Subject: Duke Energy Carolinas, LLC  
William States Lee III Nuclear Station - Docket Nos. 52-018 and 52-019  
AP1000 Combined License Application for the  
William States Lee III Nuclear Station Units 1 and 2  
Response to Request for Additional Information  
Ltr# WLG2008.11-28

**Lee Nuclear Station Response to Request for Additional Information (RAI)**

**Reference NRC RAI Number:** ER RAI 68

Attachment 68-1 ER Figure 2.4-4. Plant Railroad Spur Detour.

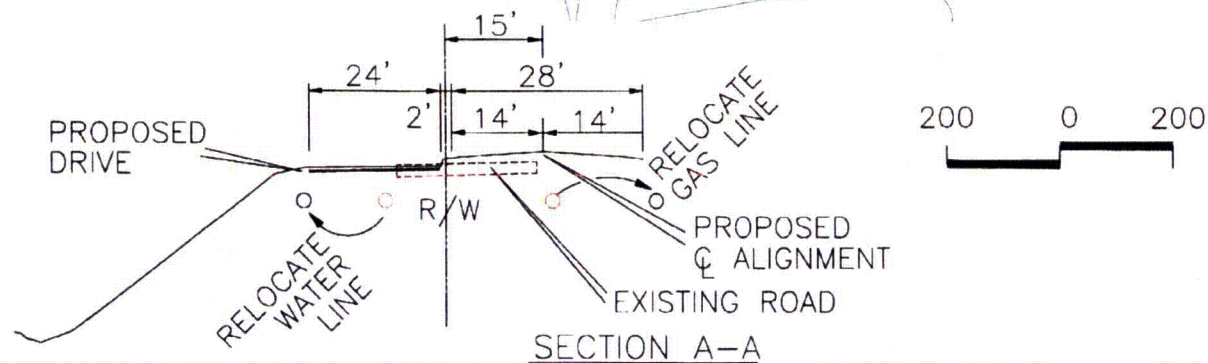
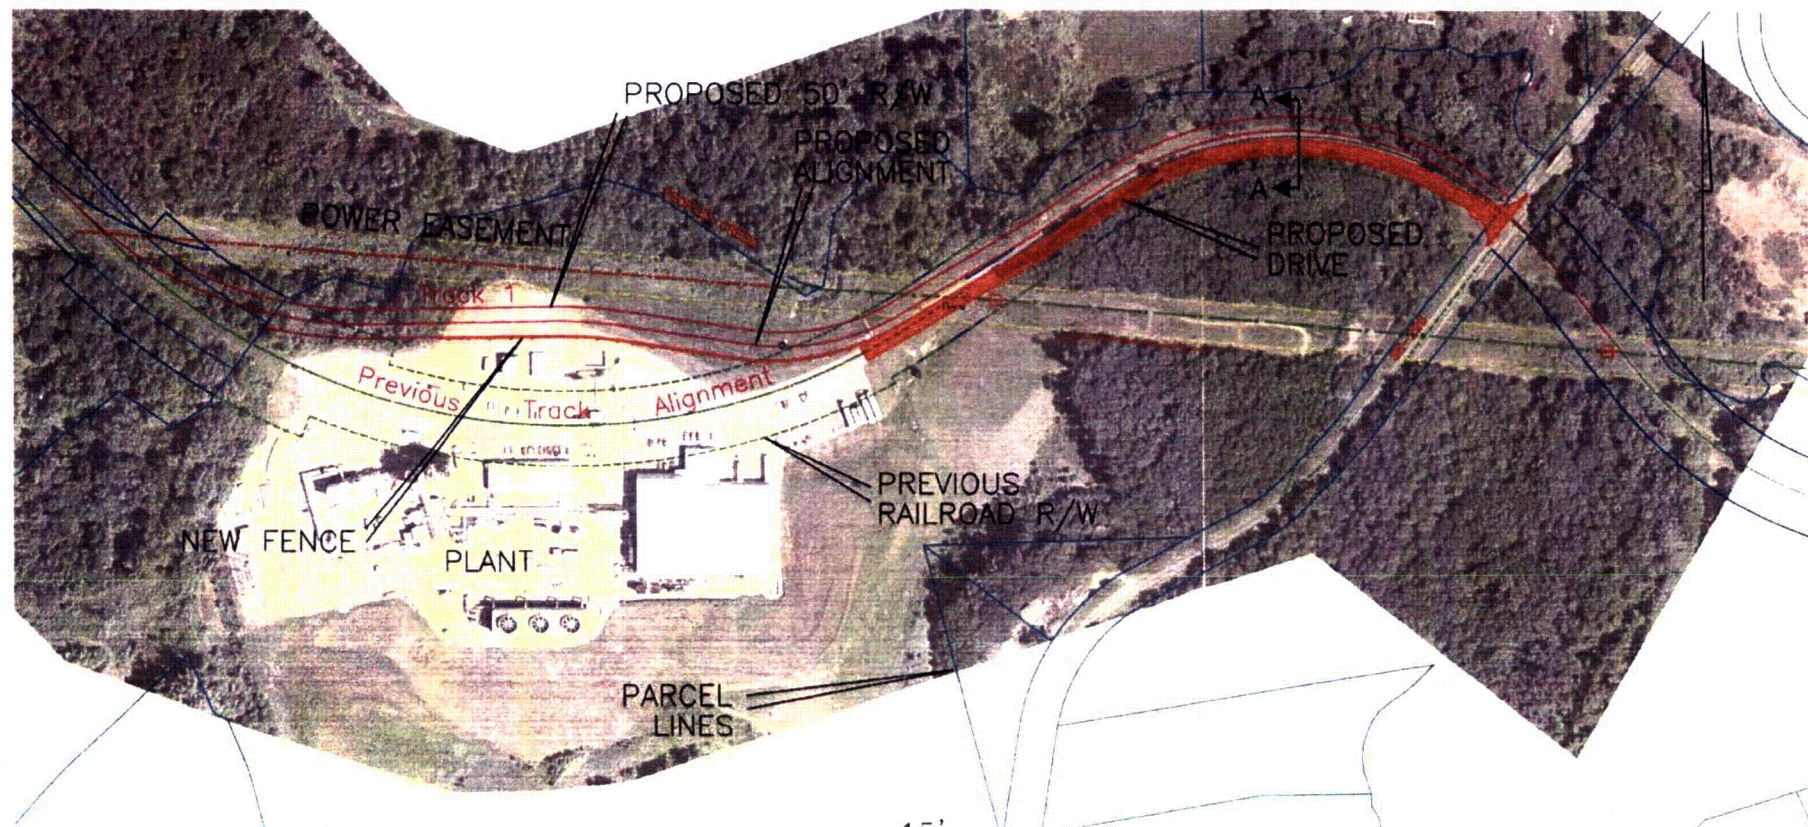
What is the final routing of the rail spur? What associated consultation has been conducted with state and federal agencies? Provide the locations(s) where any spoils from the railroad grade would be deposited.

The original railway line, detailed in ER Figure 1.1-2, was built in conjunction with the Cherokee Nuclear Station. Subsection 2.2.2 details the existing right-of-way (ROW) and track layout. When the Cherokee Nuclear Station construction project was cancelled in 1983, the track and ballast were removed from the ROW. The ROW has since reverted to private ownership but remains intact. Current owners have converted much of the ROW into a road. Duke Energy is reacquiring the ROW from current owners and plans to place new ballast and track along the existing ROW to reactivate the rail line for construction of the Lee Nuclear Station. However, Duke Energy plans a short detour from this original route at the location of the Reddy Ice Plant on the southeast edge of East Gaffney. This ice plant occupies part of the original rail bed. The detour involves approximately 1300 feet (ft.) of track (new ER Figure 2.4-4, Attachment 68-1) with a 50 ft. ROW. Within the realignment corridor, the western third is forested, and the eastern two-thirds extend across paved or maintained yard areas for the ice plant. Approximately 0.5 acres (ac.) of previously undisturbed forest are expected to be affected by the ROW.

realigned segment will create spoils, but the impact on natural areas will be limited to the short segment of the realigned track that is not already located in a paved or managed area. This impact is expected to be approximately 0.5 ac. Duke Energy anticipates requiring more "fill" material along the ROW than is going to be generated by "cutting." It is anticipated that almost no spoil material will be left over after construction of the new railway spur and the realigned segment.

4. ER Section 2.4 will be revised by adding new Figure 2.4-4 as shown in Attachment 68-1.
